The Anthem Winery Project

Comments to the Napa County Planning Commission 02/03/20 Napa, CA

Napa County Planning Department Application No. P13-00320 Application of Anthem Winery (February 5, 2020 Hearing)

subject: Review of Proposed Drainage Crossing Option 2 of the Anthem Winery Major Modification Use Permit

lower casement

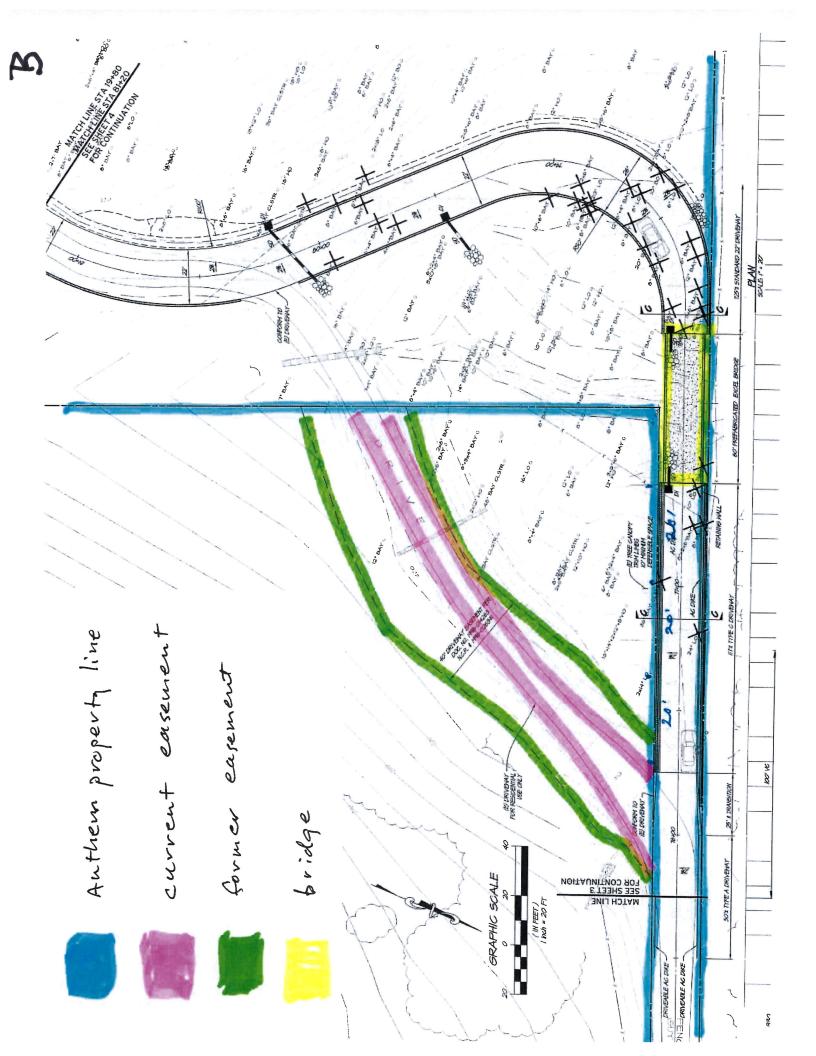
To give you further detail, there are two easements over my property that impact access from Dry Creek Road to and from the Anthem site. The Upper Easement, the approximate location of which is identified in Exhibit A attached to this letter, is located some 60 feet downhill from the bridge which the winery proposes to install. The Lower Easement, identified in Exhibit B, sits at the base of the "flagpole" road where it meets Dry Creek Road.

Similar problems confront the winery's proposed use of the Lower Easement, which is to use the Lower Easement as a "turnout area on each side of the gate" (memorandum from Patrick Ryan to Don Barrella, dated June 14, 2018, page 2 of 5). The road plans submitted by the winery do not, so far as I can see, show a turnout area on both sides of the gate; and it is not possible to create such turnout areas given the configuration of the Lower Easement. In any event, use of the Lower Easement even for one turnout on one side of the gate violates the terms of the easements as set forth above.

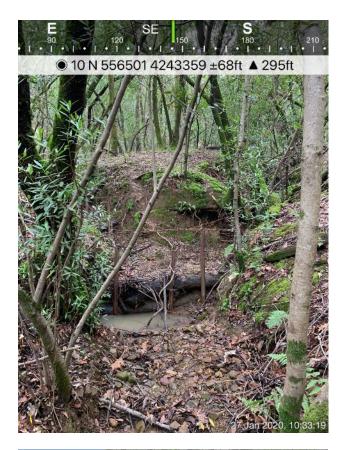
Photo 1. Looking southeast at site of proposed bridge from downstream.

Photo 2. Looking southeast at site of proposed bridge from downstream. The photo clearly shows the two drainages combining into one at this location, consistent with design drawings on Sheet 3A. Note the clearly defined and near-vertical banks. The moss-covered, double-trunked bay tree growing within the bank of the scoured western channel is also depicted Photo 3 below.

Photo 3. Close-up of trunk of bay tree depicted in Photo 2 above. As seen on the stadia rod, the top of bank exceeds 4 ft.

Photo 4. Close-up of stadia rod depicted in Photo 3 above. Note vertical bank to the left of the stadia rod.
